**Re: Rodolfo D. Farhy, M.D., FACC, FAHA, PLLC**  
**License No. 21-32564-01**  
**Notification of addition of Areas of Use**

REVISED DIAGRAM

## FACILITY DIAGRAM

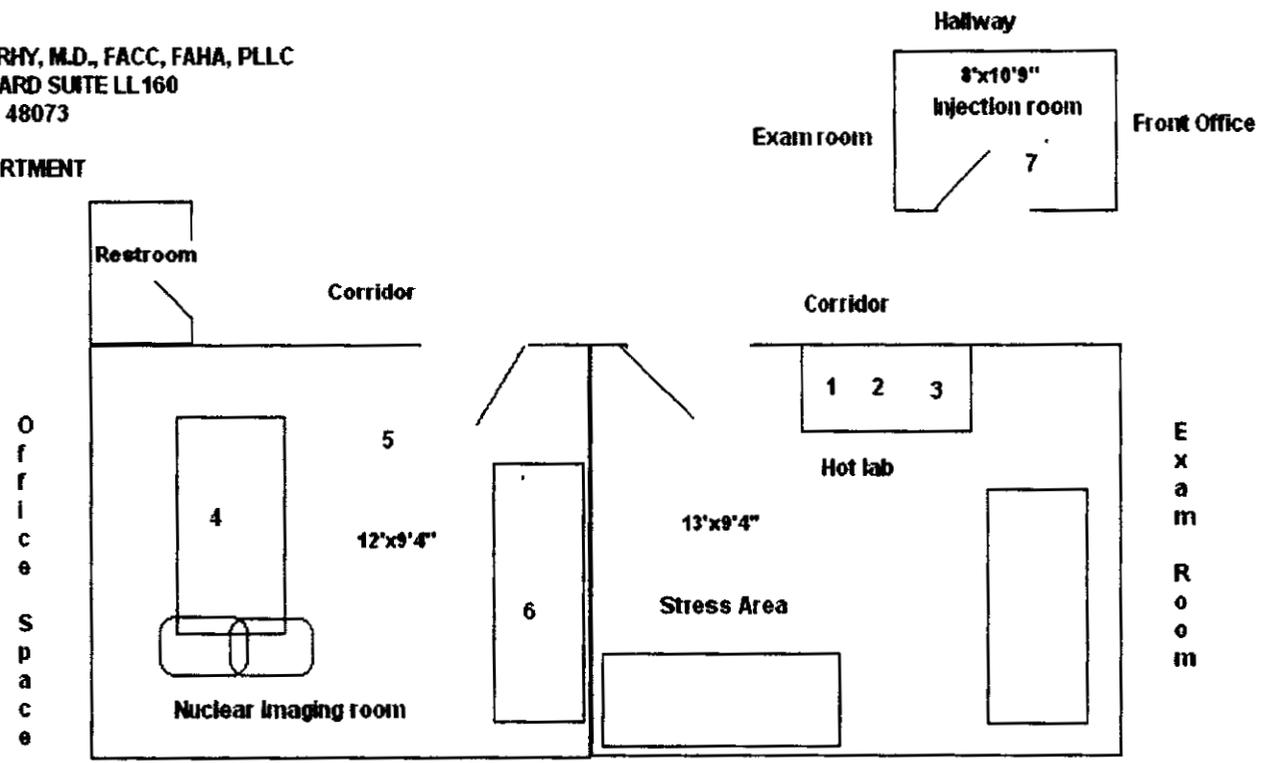
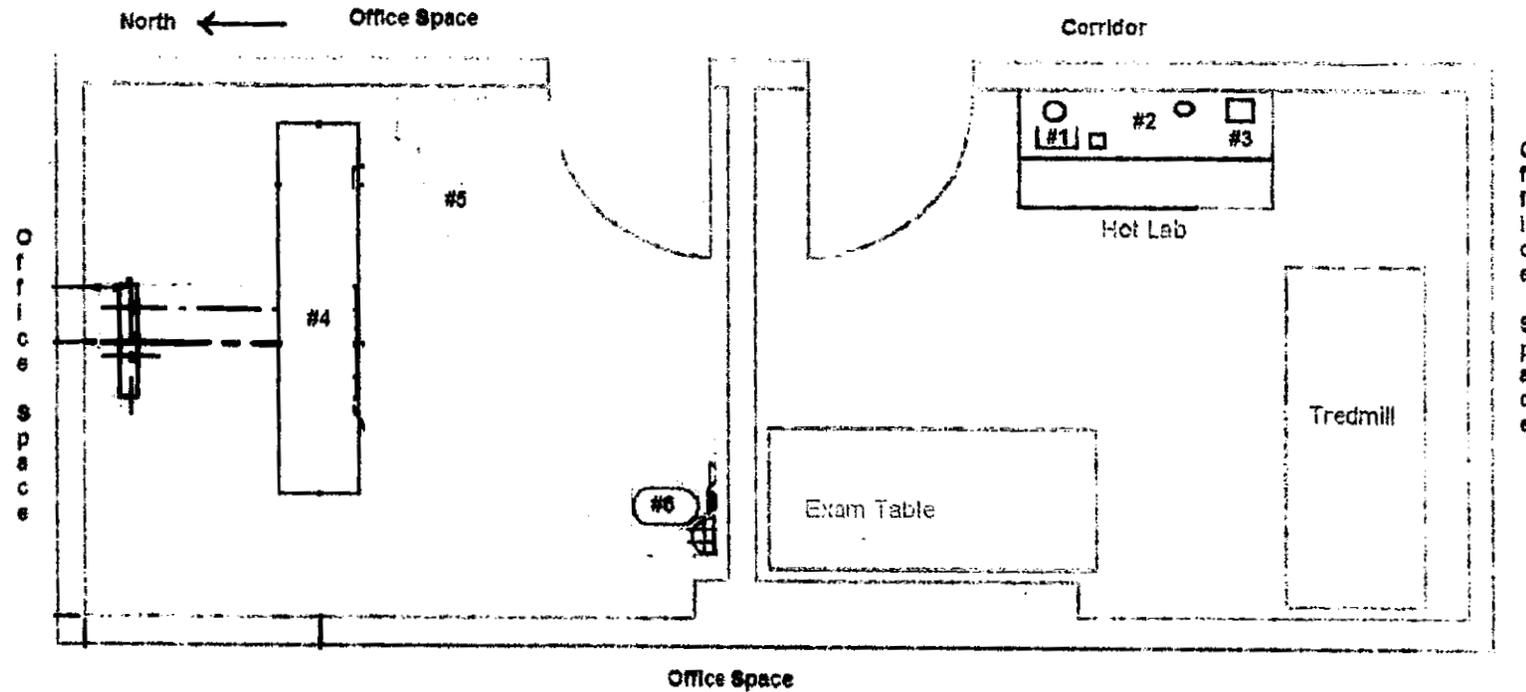
We have enclosed the original facility diagram and an updated diagram of the Areas of Use. We have added an injection room to our nuclear cardiology department. There will be no radioactive sources stored in this room. Also, there are no room numbers assigned to the nuclear areas.

- Area 1 Dose Preparation
- Area 2 Waste Storage Area
- Area 3 Package Receipt Area
- Area 4 Gamma Camera
- Area 5 Acquisition Computer
- Area 6 Processing Computer
- Area 7 Injection Room
